**PLANNING DEPARTMENT
CURRENT PLANNING DIVISION
ADMINISTRATIVE SITE PLAN REVIEW**

DATE	November 14, 2017
CASE NO:	2017-0122
APPLICANT:	Ridge Equipment, LLC
REPRESENTATIVE:	Brandon Marcott, Triad Engineering
REQUEST:	Administrative site plan review for a Land Reclamation Use in the I-2 (Heavy Industrial) District in accordance with AMC 21.05.060E.5
TITLE 21 CODE CITATION:	Title 21 – Land Use Planning, 21.05.060E.5
LOCATION:	On the west side of C Street and the south side of West 92 nd Avenue
COMMUNITY COUNCIL:	Bayshore-Klatt
TAX I.D. NUMBERS:	016-291-20
GRID:	SW2430

Case no. 2017-0122, Site Plan Review, C Street & West 92nd Avenue, Section Lot 5, SW2430

C STREET & 92nd AVENUE
TITLE SHEET

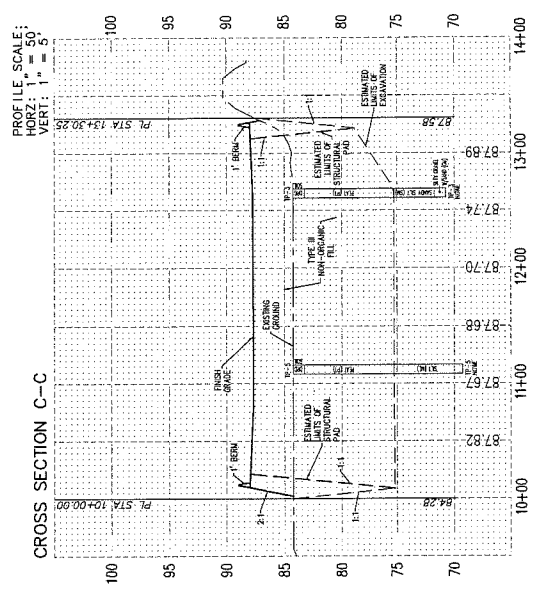
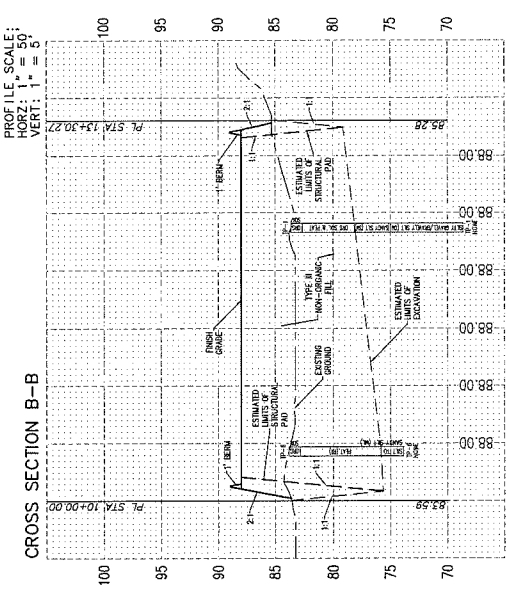
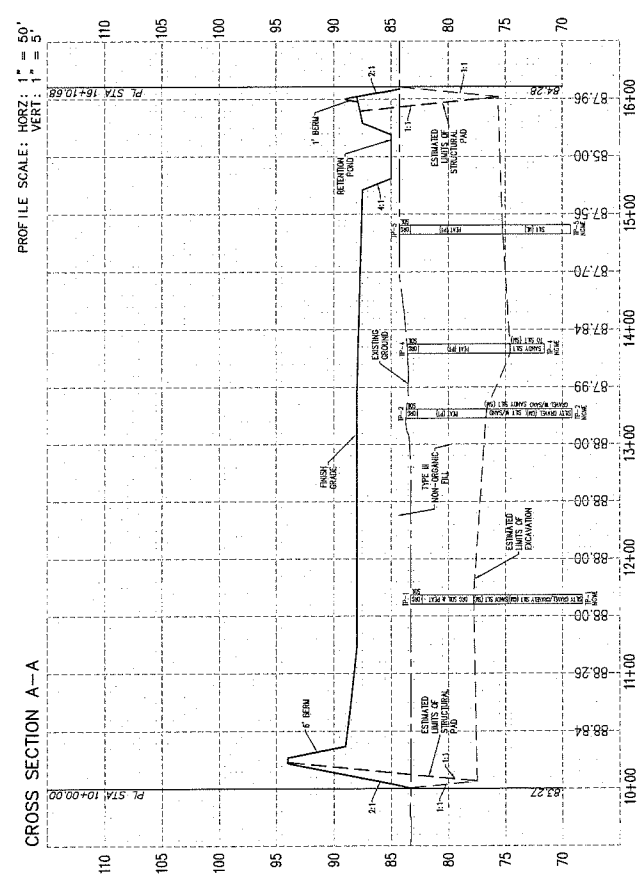
- a. In the title sheet:
 - i. In the title and lower left corner, please change "RSW" to "R3W"

SITE PLAN / LANDSCAPE PLAN
 Located on
 U.S. Government Lot 5 (Remnant)
 Township 12 North, Range 3 West, Section 18, Seward
 Meridian, Alaska

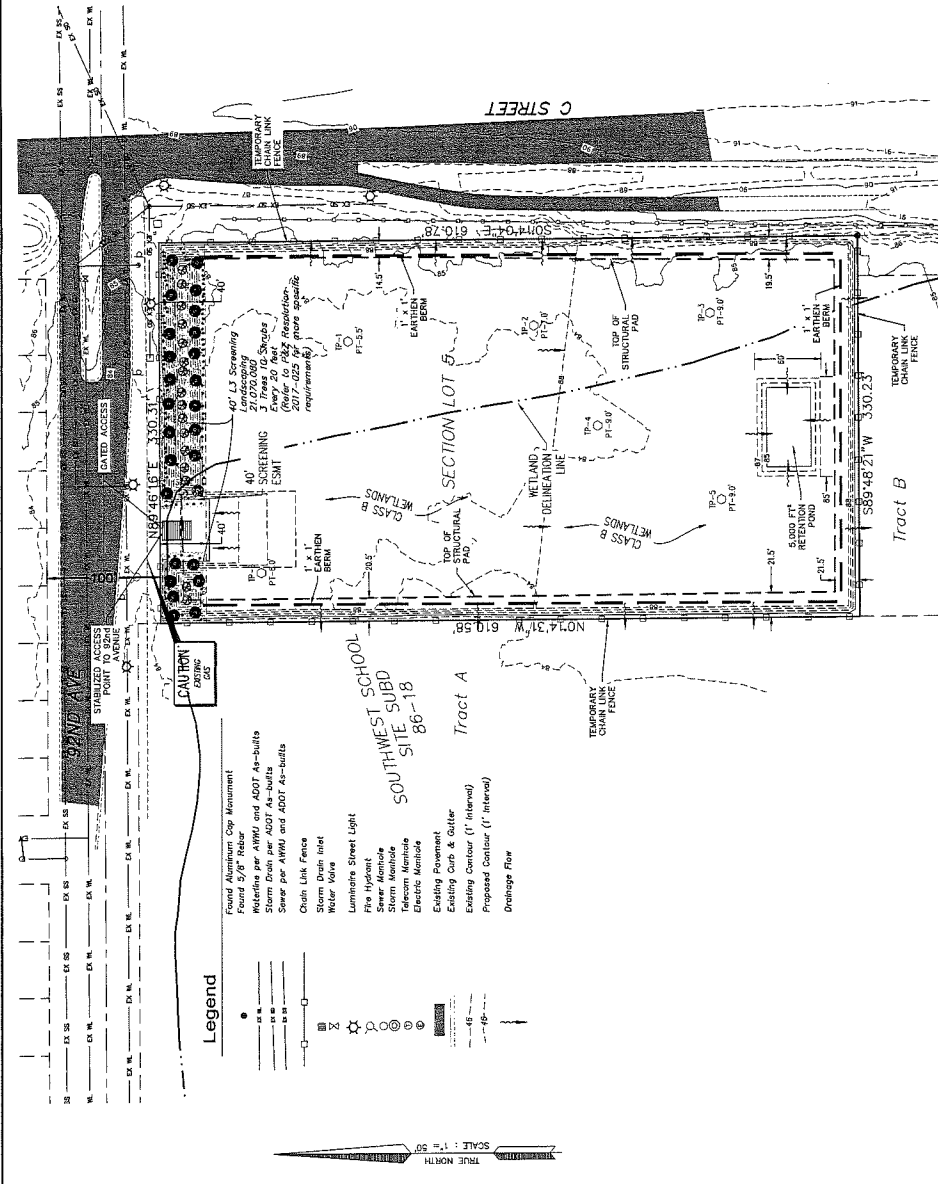
In accordance with Table 21.07-2 Minimum Site Perimeter Landscaping, L2 buffer landscaping will be required along the east petition site boundary. The buffer landscape specifications include a minimum average planting bed width of 15 feet, with minimum width at any point not less than 10 feet; installation of 2 trees and 6 shrubs per 20 linear feet with a minimum of at least one-half of the trees to be coniferous. The landscaping plan shown on Sheet L1 provides information on the proposed landscaping. However, the landscaping plan does not meet the requirements of AMC 21.07.080C.2.a-I that requires:

- A plan scale not smaller than one inch equals 30 feet;
- The common and scientific name for each plant type or ground cover to be used;

- The plan locations and sizes in accordance with the sizing standards of the American Standard for Nursery Stock;
- The locations and areas where existing native vegetation is being used to fulfill the requirement;
- Location of buildings, walkways, vehicular circulation, retaining walls, and fences;
- Topography expressed in contours or spot elevations, shall be identified on plans;
- All drainage features to include swales: biofiltration swales, drainage basins, snow storage and disposal area, and any inlets for storm drains shall be identified;
- Existing and proposed utility elements;
- Planting details;
- North arrow and scale shall be included.

1. All construction and improvements related to this approval shall be substantially in compliance with the approved administrative site plan, narrative, and plans submitted to the Planning Division, unless otherwise amended to satisfy the approval conditions.
2. A notice of zoning action and final approved site plan shall be filed with the State Recorder's Office. Proof of such shall be submitted to the Planning Department.
3. All land reclamation operations shall be complete within one year of the approval of the proposed site plan.
4. Revise the site plan to show L2 landscaping along the east boundary of the petition site that adjoins an R-1 single-family residential subdivision.
5. Submit a landscaping plan that meets the requirements of AMC 21.07.080C.2.a-i.
